**Promulgation of Air Quality Implementation Plans; State of Texas; Regional Haze and  
Interstate Visibility Transport Federal Implementation Plan**

**ADDRESSES:** Submit your comments, identified by Docket No. EPA-R06-OAR-2016-0611, at <http://www.regulations.gov> or via email to [R6\\_TX-BART@epa.gov](mailto:R6_TX-BART@epa.gov). Follow the online instructions for submitting comments. Once submitted, comments cannot be edited or removed from Regulations.gov. The EPA may publish any comment received to its public docket. Do not submit electronically any information you consider to be Confidential Business Information (CBI) or other information whose disclosure is restricted by statute. Multimedia submissions (audio, video, etc.) must be accompanied by a written comment. The written comment is considered the official comment and should include discussion of all points you wish to make. The EPA will generally not consider comments or comment contents located outside of the primary submission (i.e. on the web, cloud, or other file sharing system). For additional submission methods, please contact Joe Kordzi, 214-665-7186, [Kordzi.joe@epa.gov](mailto:Kordzi.joe@epa.gov). For the full

Figure 1: EPA SO<sub>2</sub> Emission Trend Data for Milton R. Young Unit 1 (Source: Docket ID No. EPA-R06-OAR-2016-0611-0008, TX187-0008-0033-BOD-Selected BOD SO<sub>2</sub> Averages-3)

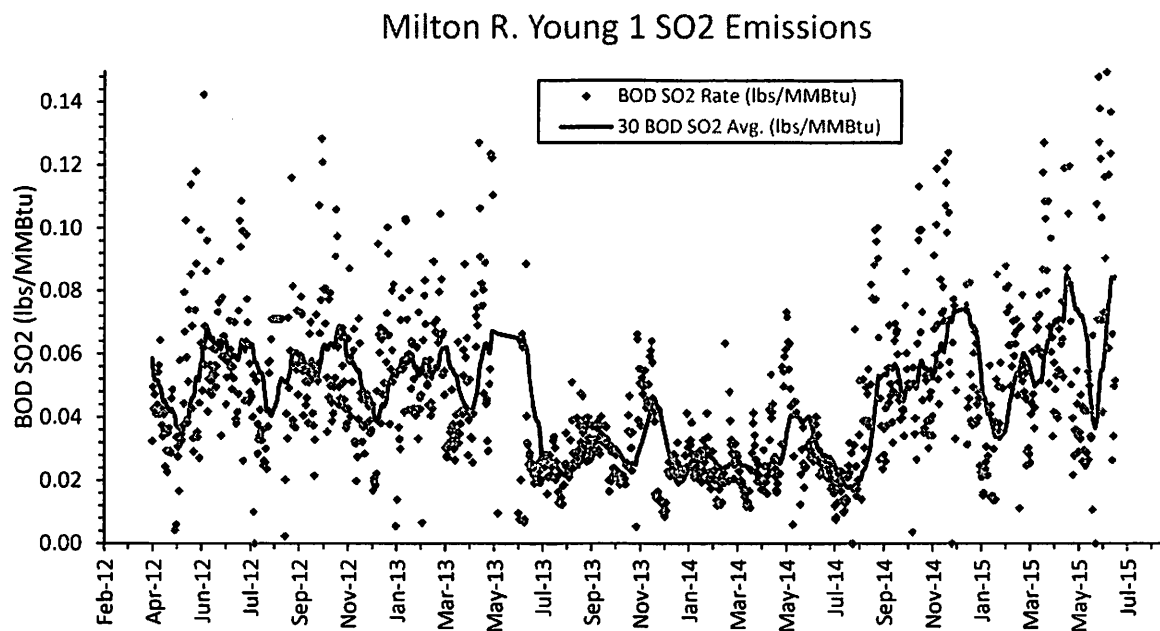
The EPA also attempts to support its 0.04 lb/MMBtu limit by highlighting three particular units: Scherer Unit 2, Iatan Unit 1, and Boswell Energy Center (Technical Support Document for the Texas Regional Haze BART Federal Implementation Plan, BART FIP TSD, Docket ID No. EPA-R06-OAR-2016-0611-004, page 122). The EPA cites these units as operating at levels of 0.01 to 0.03 lb/MMBtu for sustained periods. However, not only are these units fired with Powder River Basin (PRB) subbituminous coal, only the Boswell Energy Center Unit 3 is a BART-eligible unit.

EPA Region 6 has not justified why its proposed BART determinations for SO<sub>2</sub> control on coal-fired EGUs in Texas are inconsistent with other EPA BART determinations. The proposed SO<sub>2</sub> limit for retrofit wet scrubbers on lignite-fired units is not supported by the EPA's own data provided with the proposed FIP. The EPA should not arbitrarily assume that wet FGD scrubbers on lignite-fired units can achieve the same level of SO<sub>2</sub> emission rate on a lb/MMBtu basis as low-sulfur PRB subbituminous coal-fired units.

Figure 2: EPA SO<sub>2</sub> Emission Trend Data for Jeffrey Energy Center Unit 3 (Source: Docket ID No. EPA-R06-OAR-2016-0611-0008, TX187-0008-0033-BOD-Selected BOD SO<sub>2</sub> Averages-3)

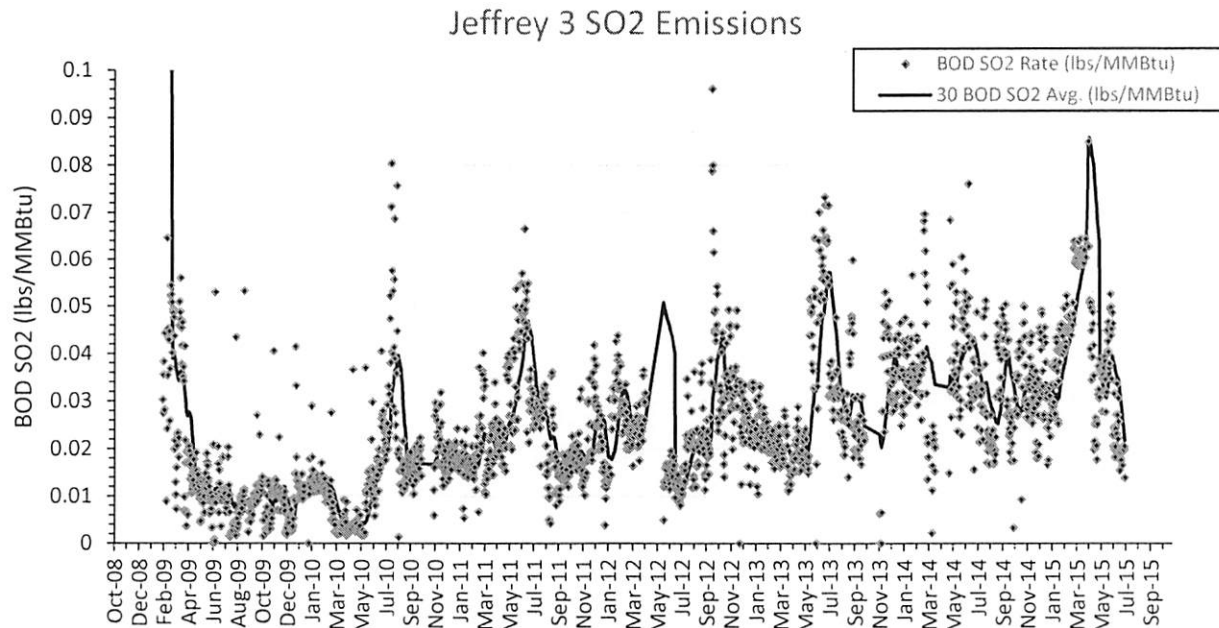
The EPA's proposed emission standards apply at all times, including startup and shutdown operations. However, the EPA has not given proper consideration to emission spikes that can occur during startup operations that can cause a significant spike in even a 30-boiler operating day average until the startup day rolls out of the 30-day average. The EPA's own emissions trend data provided in the technical support documents demonstrates that such spikes would represent a compliance problem for some of the units that the EPA evaluated in establishing the proposed BART emission standards. Figures 2 and 3 provide examples from the EPA's technical support document with selected 30-boiler operating day average data (Docket ID No. EPA-R06-OAR-2016-0611-0008, TX187-0008-0033-BOD-Selected BOD SO<sub>2</sub> Averages-3) for two units with wet FGD. While all the spikes in the SO<sub>2</sub> emissions trend for Jeffrey Energy Center Unit 3 and James H. Miller Unit 4 may not necessarily be associated with startup operations, the EPA's data demonstrates the significant variation that can occur in SO<sub>2</sub> emission rates even when using a 30-boiler operating day average which the EPA has not accounted for in selecting the proposed emission limits for retrofit scrubbers.

Figure 4: Coal-fired EGU Age Profile (United States Department of Energy, EIA, 2015 Form EIA-860 data).

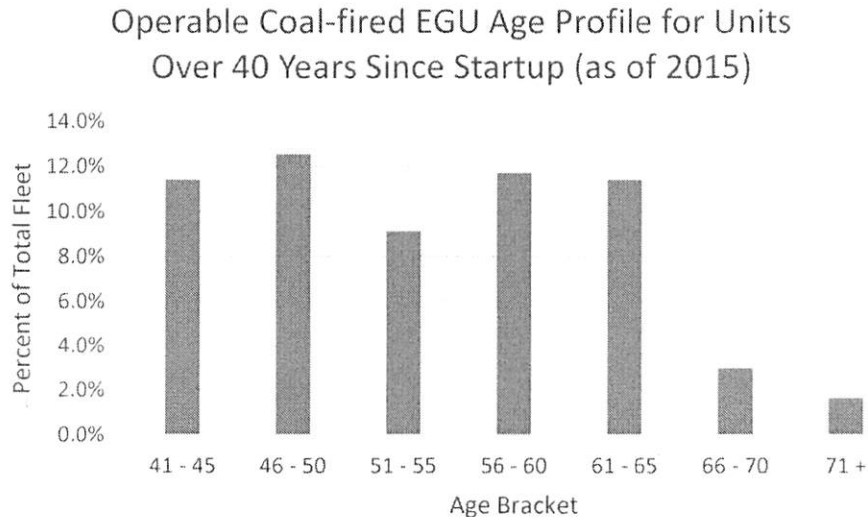
**The EPA's selection of 30 years as the remaining useful life of the BART affected units is arbitrary and overestimated for the affected coal-fired EGUs in Texas. The EPA's overestimated remaining useful life grossly biases the EPA's cost effectiveness calculations for certain emission controls.**

While coal-fired EGUs can remain operational for 60 - 70 years and the affected BART units could theoretically last another 30 years, the EPA's selection of 30 years for the remaining useful life of these units is arbitrary and does not take into consideration the current state of the energy sector and many other factors that will affect how long these units will continue to remain operational. The age of the coal-fired EGUs subject to the EPA's proposed FIP range from 35 to 46 years, which the average being approximately 40 years. EPA's assumed 30 years of remaining useful life assumes these units will remain operational until they are 65 to 76 years old. However, this assumption does not reflect actual operational life data from the United States Department of Energy, Energy Information Administration (EIA). Figure 4 presents the age brackets for operable coal-fired EGUs with over 40 years of operation, based on EIA's 2015 Form EIA-860 data. Less than 5% of the operable fleet in 2015 was greater than 65 years in age.

For units in EIA's 2015 Form EIA-860 data with expected retirement dates, the average expected age at retirement is only 53 years and the median age is 57 years. Based on just the current age profile of the units affected by the EPA's proposed FIP and the EIA information from Form EIA-860, the expected remaining useful life of these units is more likely between 10 - 20 years, not the 30 years assumed by the EPA. Other factors, such as the current energy sector market pressure and other regulatory impacts, could shorten the remaining useful life even further.

Figure 5: Cost Effectiveness Comparison for Welsh #1

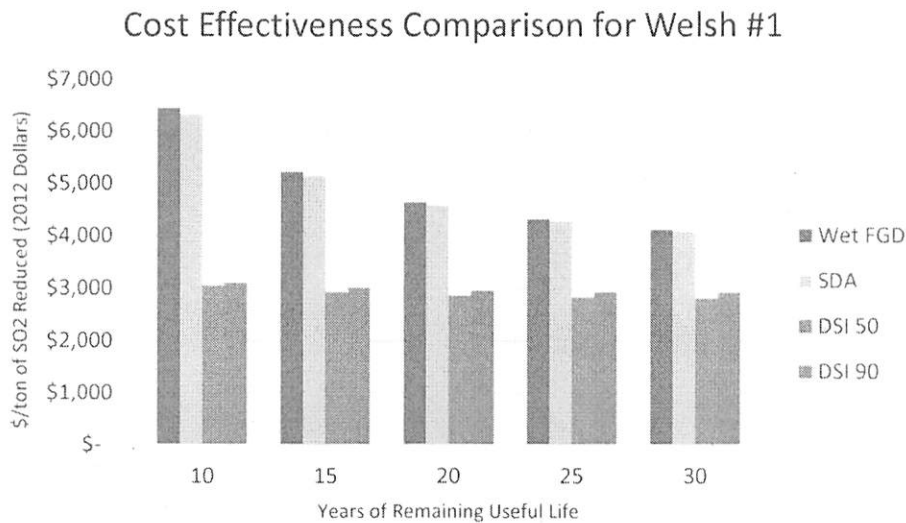
Furthermore, the EPA's cost effectiveness calculations of some of the technologies evaluated by the EPA are significantly biased as a result of using a 30-year time for annualizing capital costs. While the cost effectiveness of DSI remains relatively flat over different time periods for remaining useful life due to its relatively low capital costs, cost effectiveness estimates for wet FGD and SDA are significantly impacted by the time period assumed for remaining useful life due to the far higher capital costs associated with those technologies. Figure 5 illustrates the impact of remaining useful life assumed when calculating cost effectiveness on the same technologies evaluated by the EPA using the EPA's same cost estimates. The EPA's cost effectiveness estimates for wet FGD and SDA are severely underestimated as a result of the EPA's artificially high remaining useful life estimate.

Figure 6: Comparison of Natural Conditions Estimates

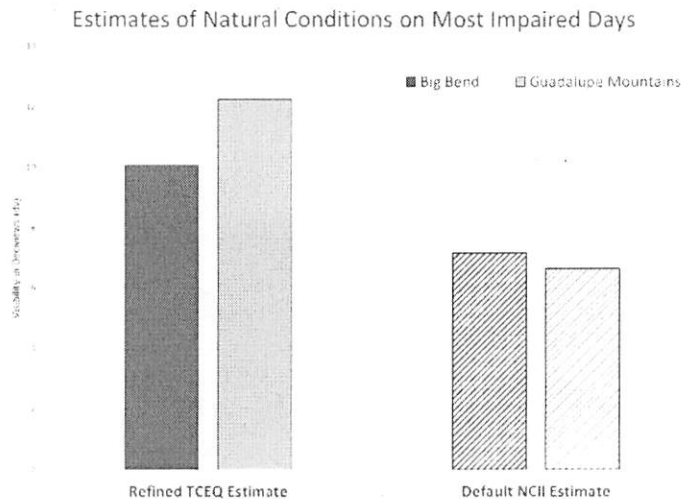
representative estimates of natural conditions calculated by the TCEQ are higher than the default NCII values used by the EPA.

## 2017 Air Markets SO2 Emissions, lbs/MMBtu

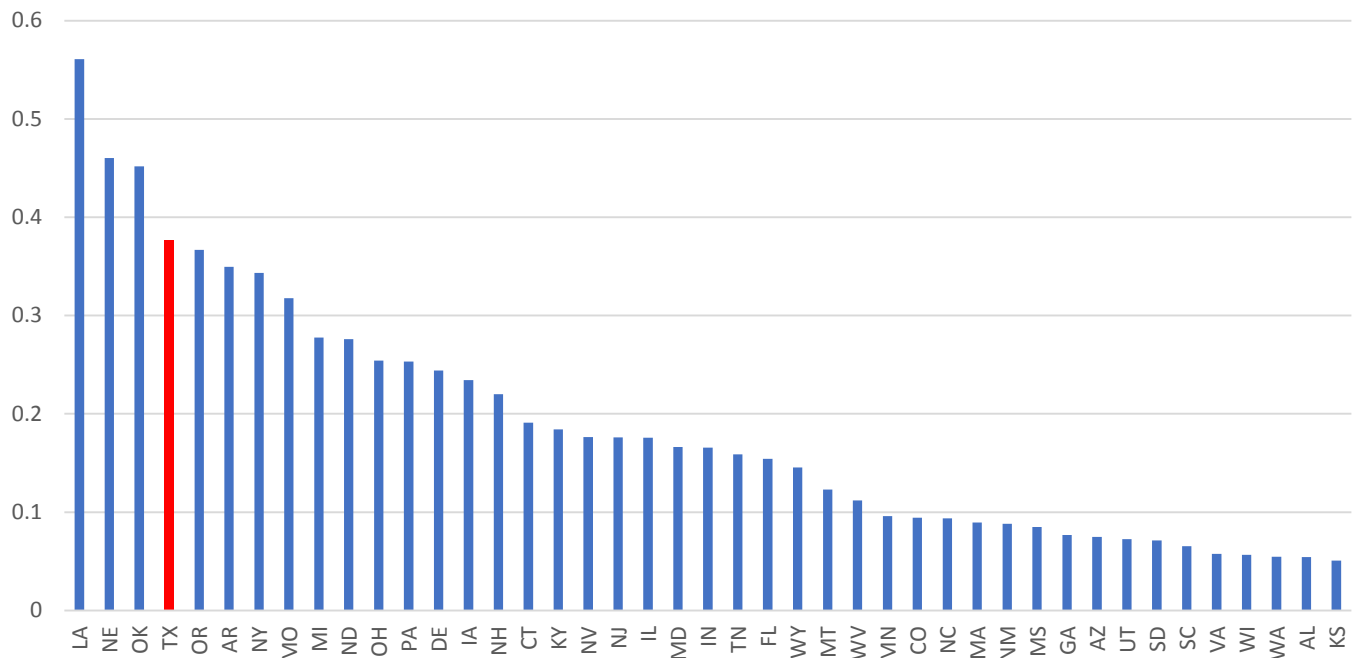
The figure below<sup>7</sup> compares the average SO<sub>2</sub> emission rate of all Texas coal units in 2017 to the corresponding emission rate for other states' coal fleets. This figure includes Texas units that have since retired. The bar in red represents the SO<sub>2</sub> emission rate of Texas coal units.

## 2017 Air Markets SO<sub>2</sub> Emissions, lbs/MMBtu

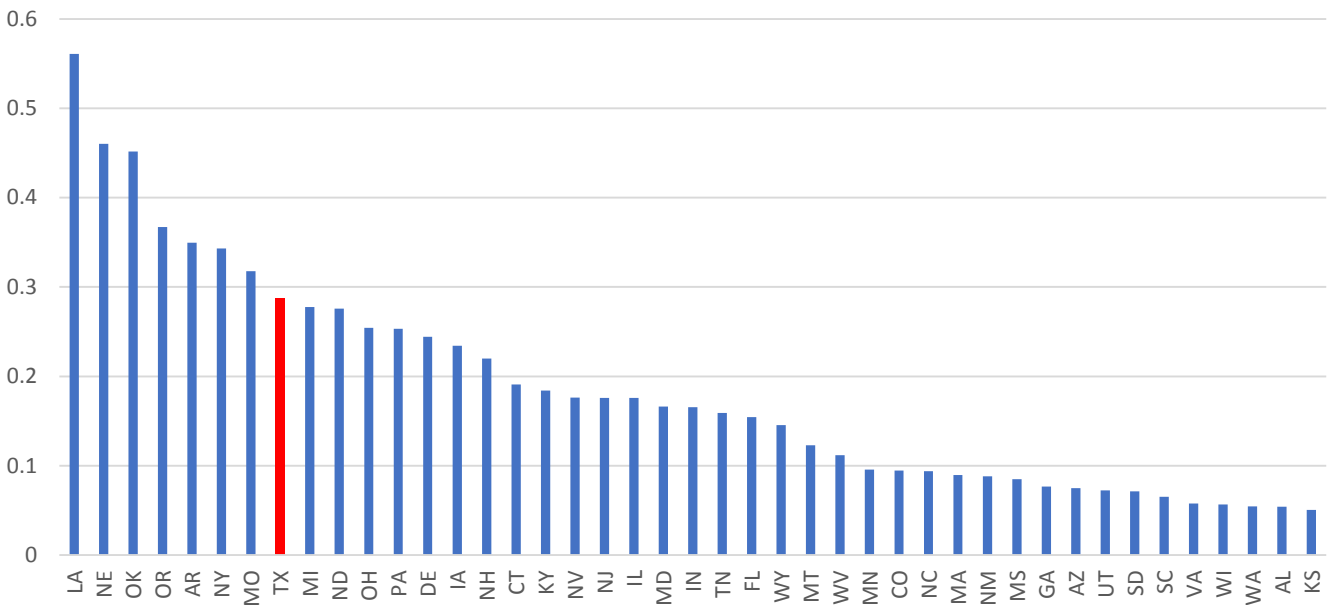
The following figures<sup>8</sup> makes the same comparison, but removes Texas units that have retired as of the date of these comments as well as JT Deely, which has announced it will retire by the end of 2018. The bar in red represents the SO<sub>2</sub> emission rate of Texas coal units.
